EXTENDICARE RIVERSIDE – 400 JESSIE CHENEVERT SERVICING BRIEF

Prepared for Extendicare Inc.
by ARCADIS

November 2025

WATERMAIN DEMAND CALCULATION SHEET

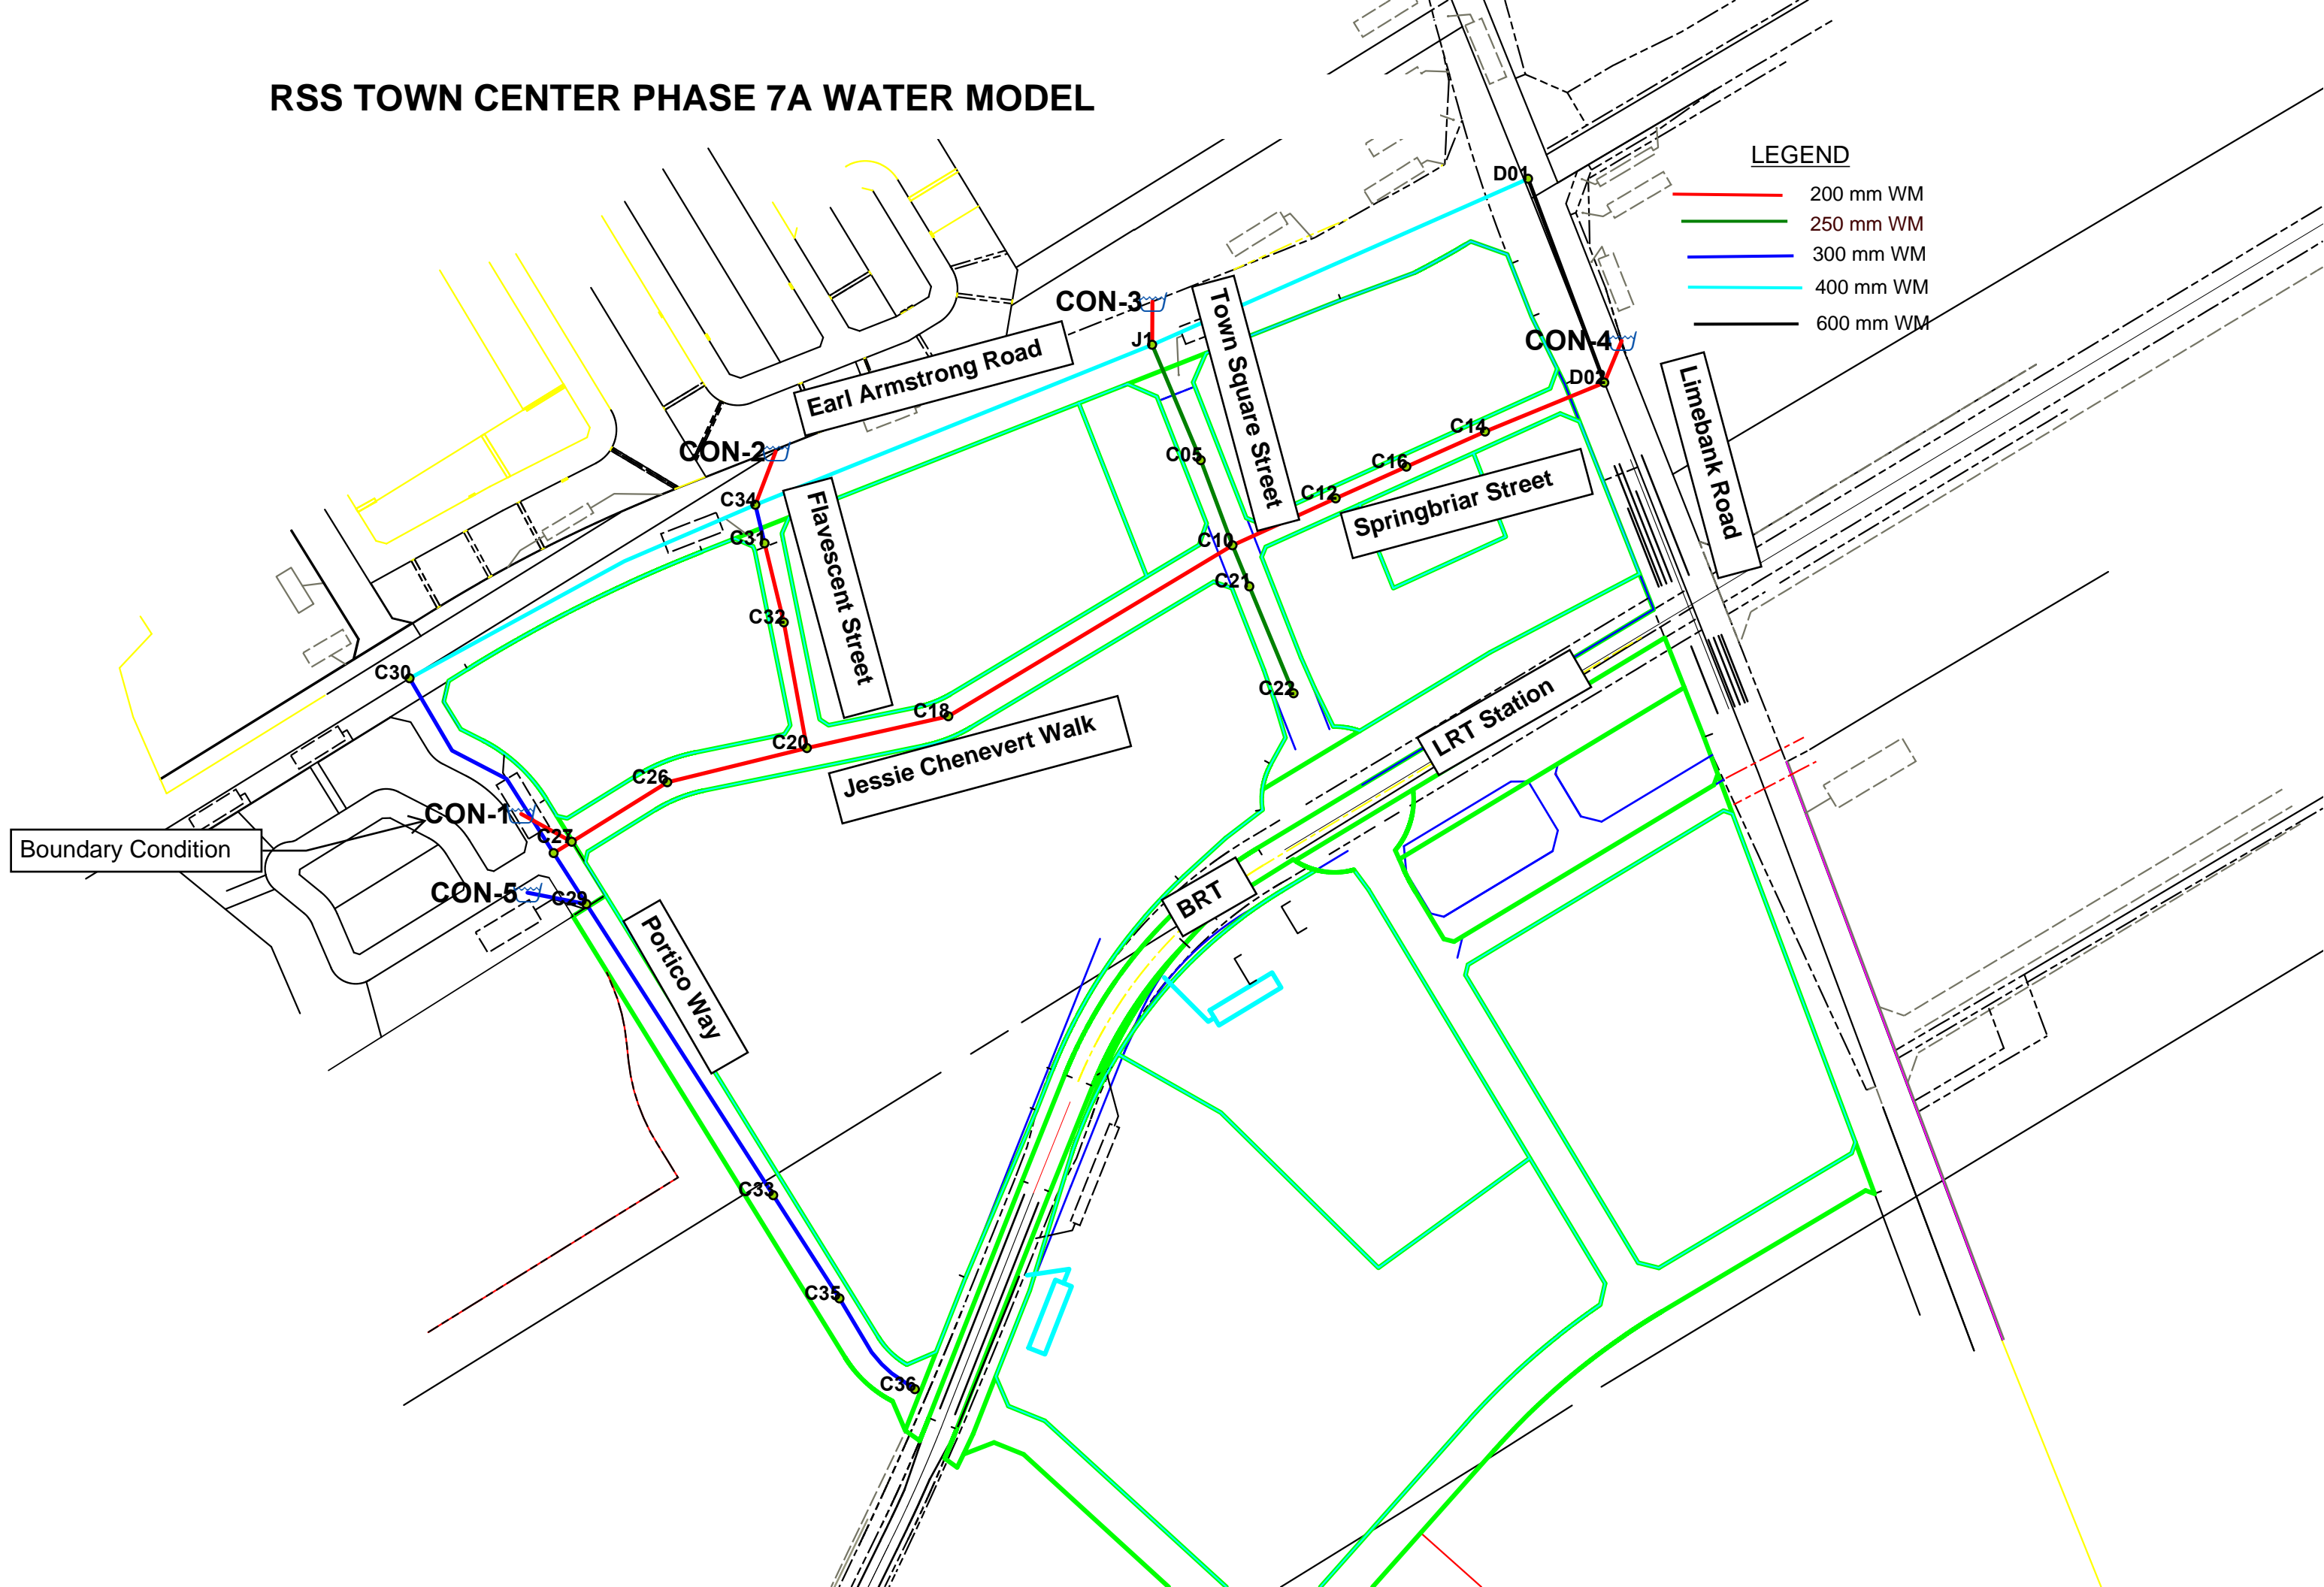
Long Term Care is considered institutional. The population is less than 500 persons. Please refer to MOE guidelines for avg demand, peaking factors and sewage demand.

Arcadis: revised to use ICI

SANITARY SEWER DESIGN SHEET

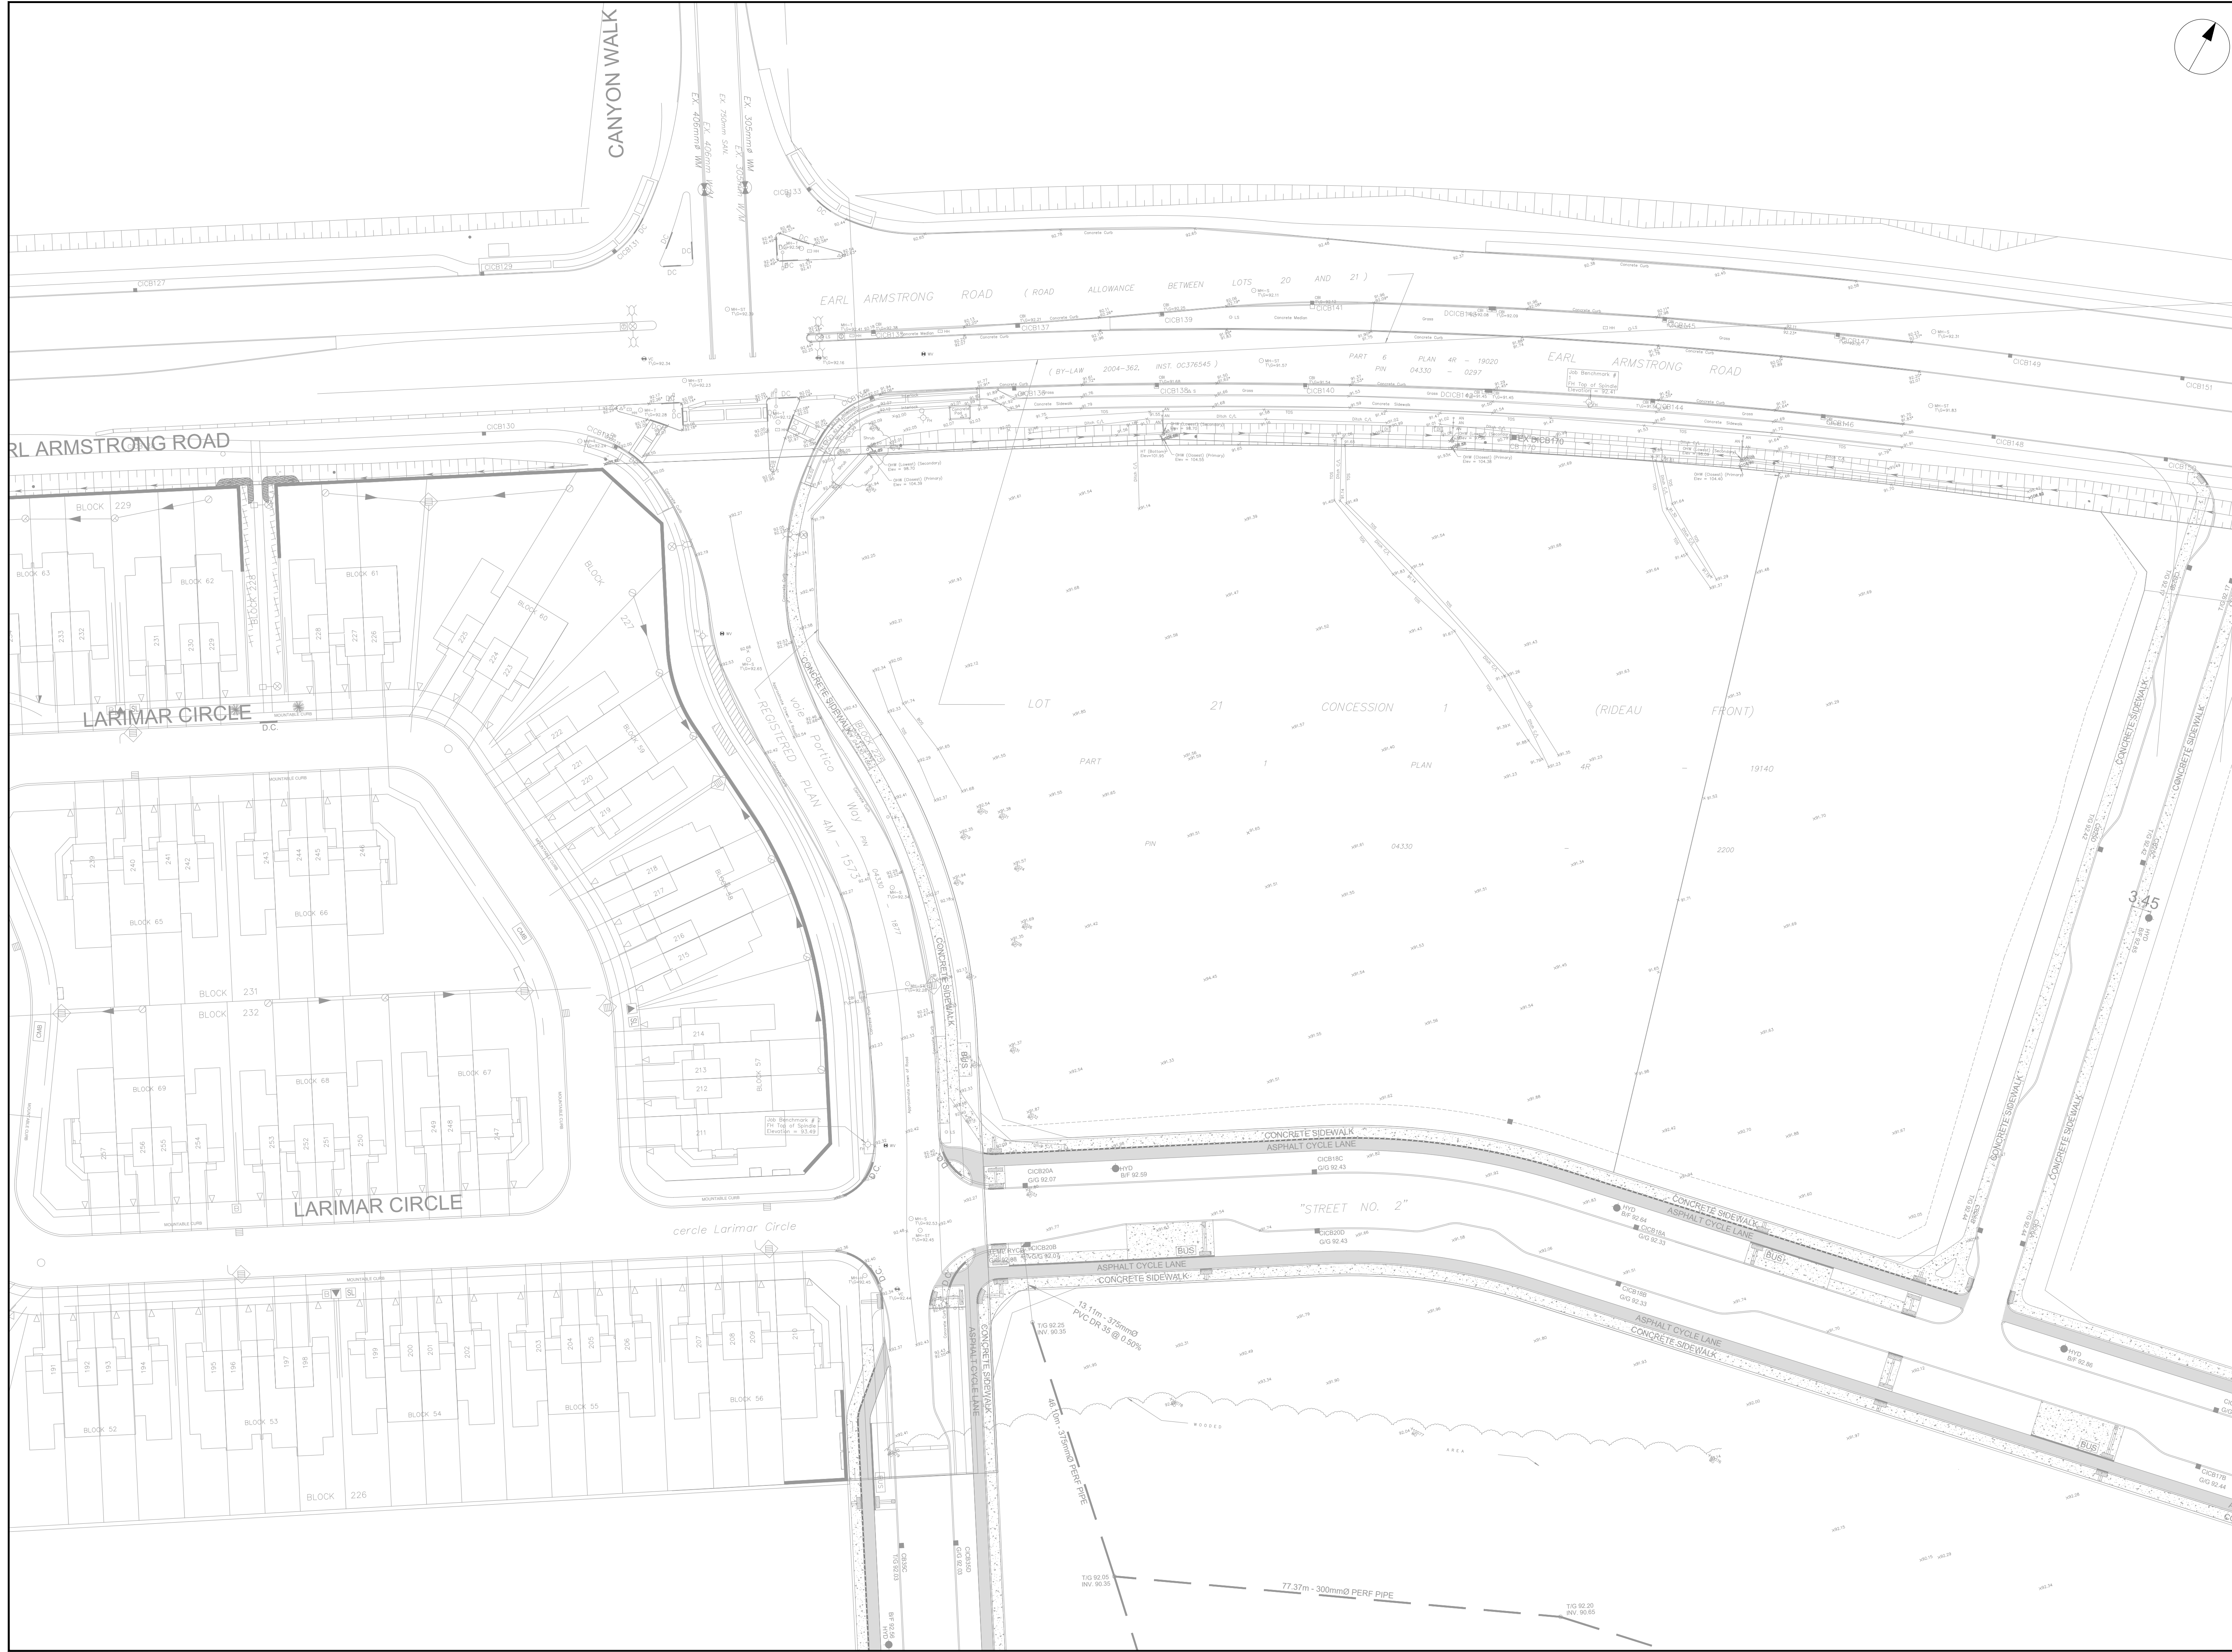
Long term care is institutional. Please refer to MOE guidelines.

Arcadis: revised to
use ICI
